1. Waterloo Metro Quarter Over Station Development – Response to Authority Comments – Northern Precinct (SSD – 10440)

ptc. have been engaged by WL Developer Trust (WLD) to prepare a response to the traffic and parking related comments raised by the authorities in relation to the proposed Waterloo Metro Quarter Over Station Development, Northern Precinct (SSD – 10440).

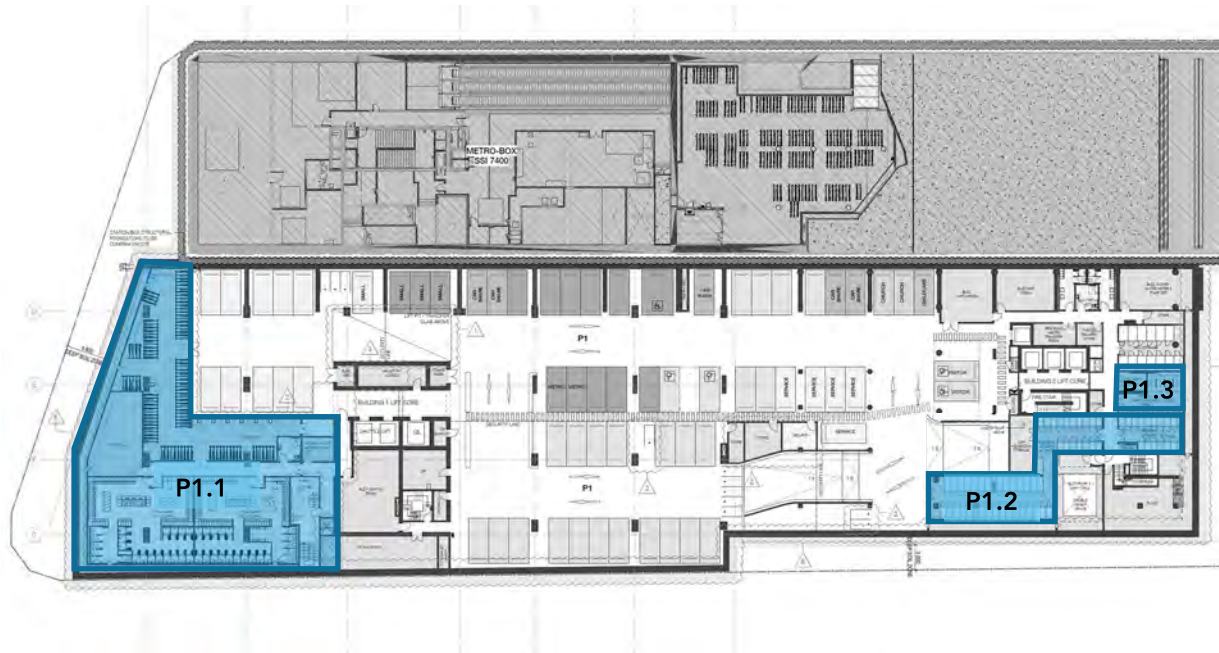
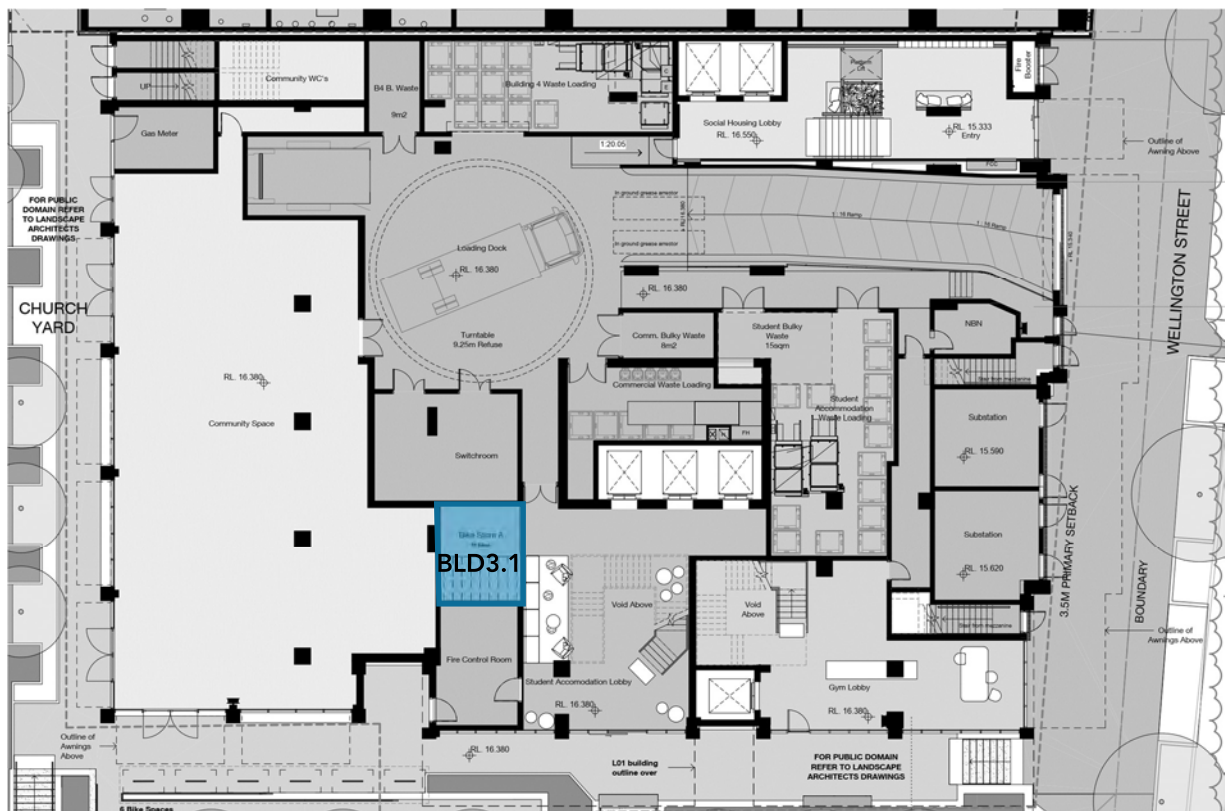
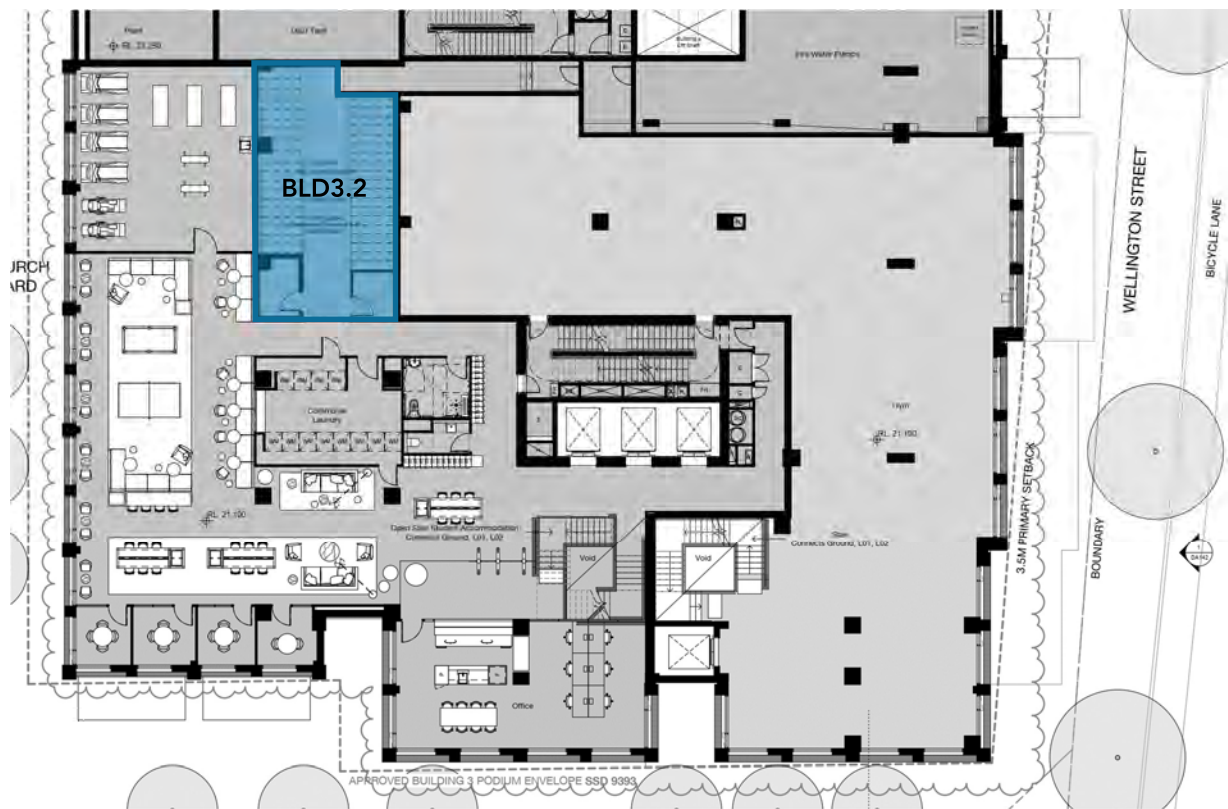
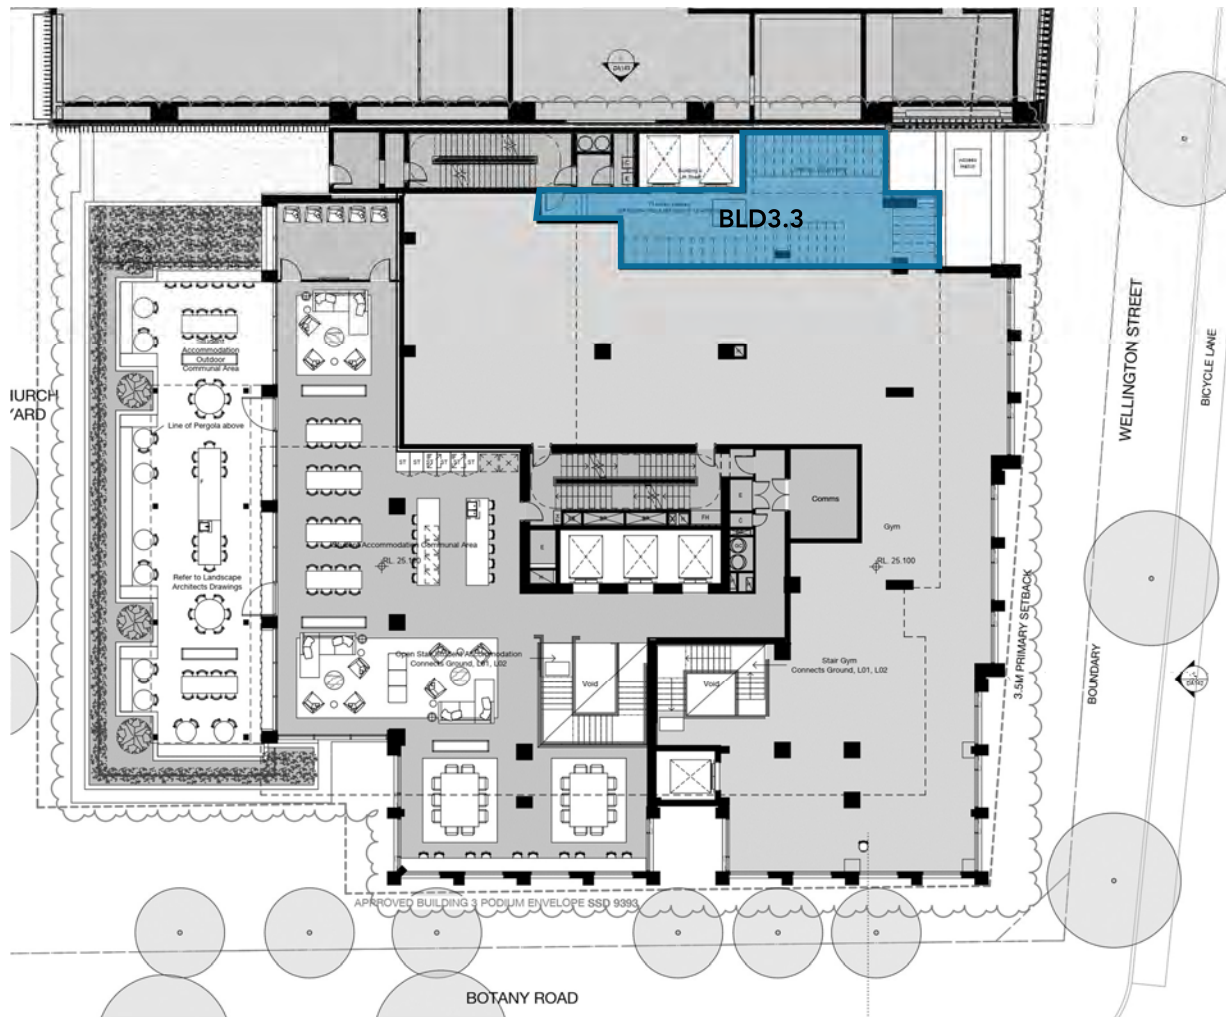
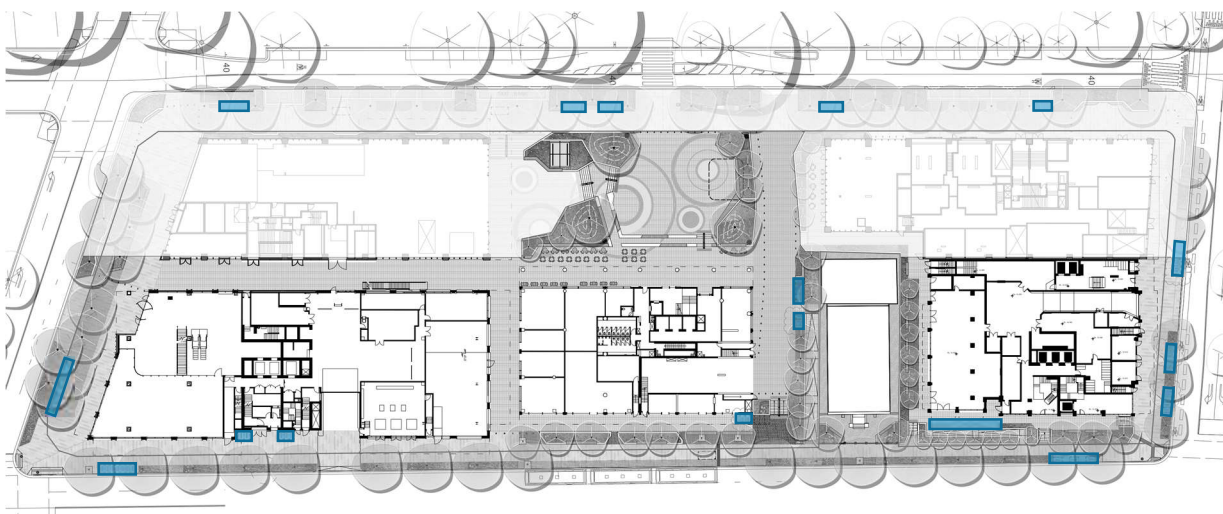
The applicant should locate bicycle facilities in secure, convenient, accessible areas close to the main entries, incorporating adequate lighting and passive surveillance and in accordance with Austroads guidelines; and

The applicant should undertake annual staff travel surveys for the entire Waterloo Metro Quarter (WMQ) and allocate bicycle parking and End of Trip (EoT) facilities for residents, staff and bicycle couriers based on the results of the travel surveys during the operation of the development.

Bicycle parking and EoTF have been located in secure, convenient and accessible locations in accordance with Austroads and Australian Standards. Details of the location of the proposed bicycle facilities are shown on the concept architectural drawings prepared by Woods Bagot and Bates Smart and the public domain landscape drawings prepared by Aspect Studios. A summary of the proposed bicycle parking and EOTF provisions is outlined in Table 1.

A Green Travel Plan (GTP) was submitted as part of the SSDA application will be revised during the post-approval stages in consultation with TfNSW, prior to implementation of the GTP and the issue of the Occupation Certificate. As part of the post development GTP process, annual staff travel surveys will be undertaken and based on these results bicycle parking allocation will be reviewed.

Figure 6 - Access to Retail Tenancies from Northern Loading Dock

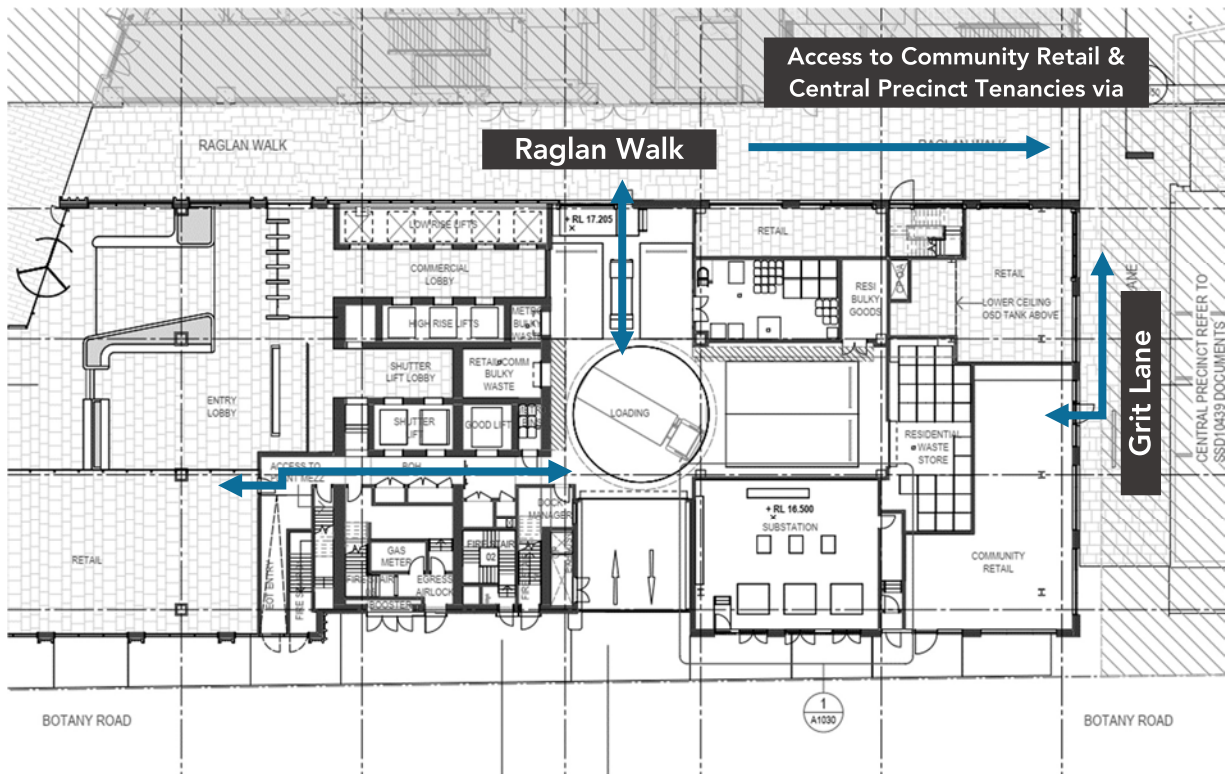
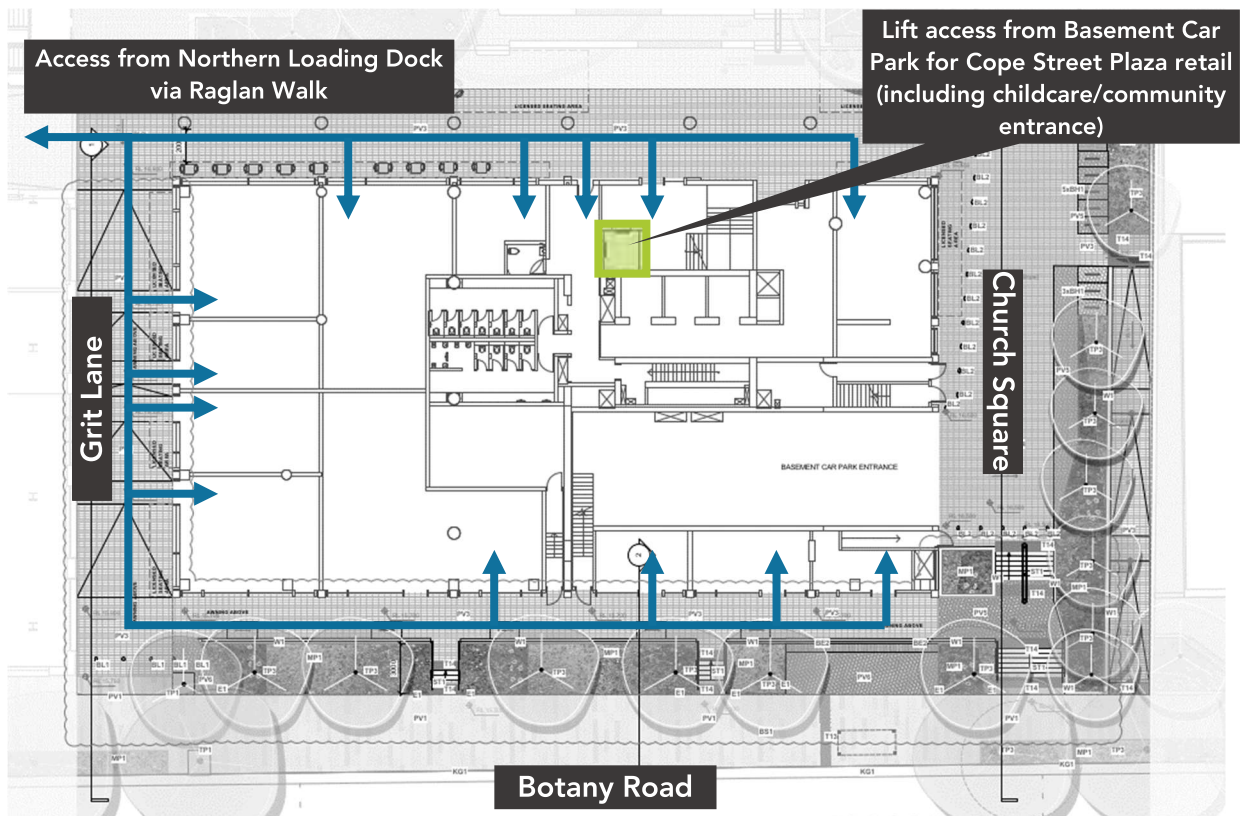
Provide further information on how the proposed retail premises can be serviced from basement loading docks.

Access from the Central Precinct retail tenancies to the Northern loading dock is provided in the following diagrams.

Figure 1 - Cope Street and Raglan Street Intersection Upgrade

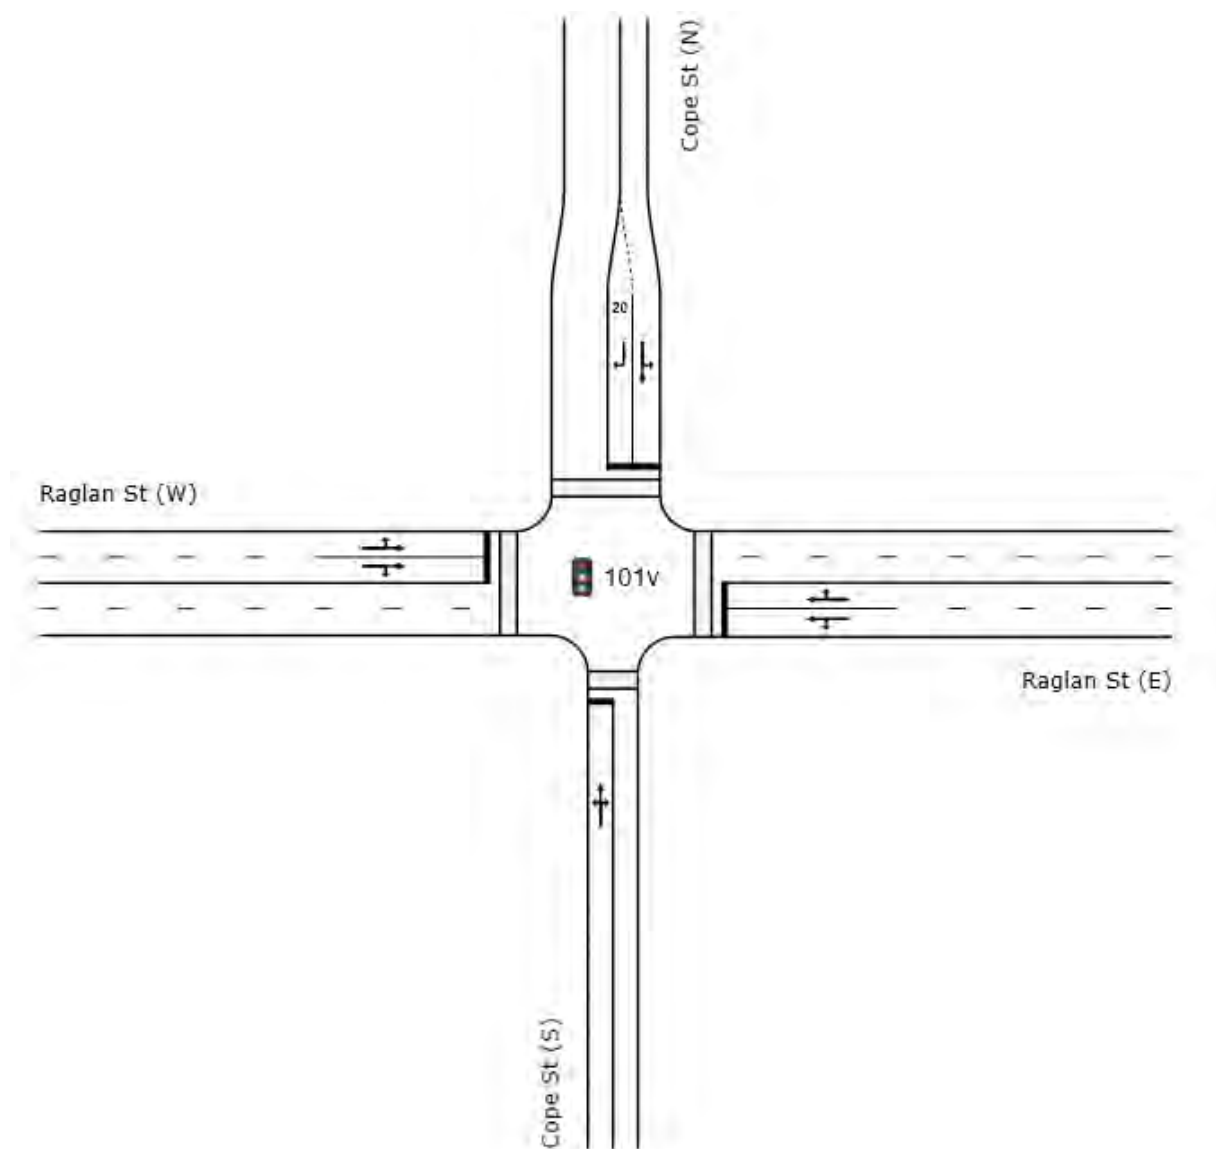
The traffic modelling should include changes to the street network and intersections proposed as part of the Metro development.

The intersection is currently configured as a roundabout. The intersection is planned to be converted to a signalised intersection. The arrangement of the intersection is illustrated in Figure 1.
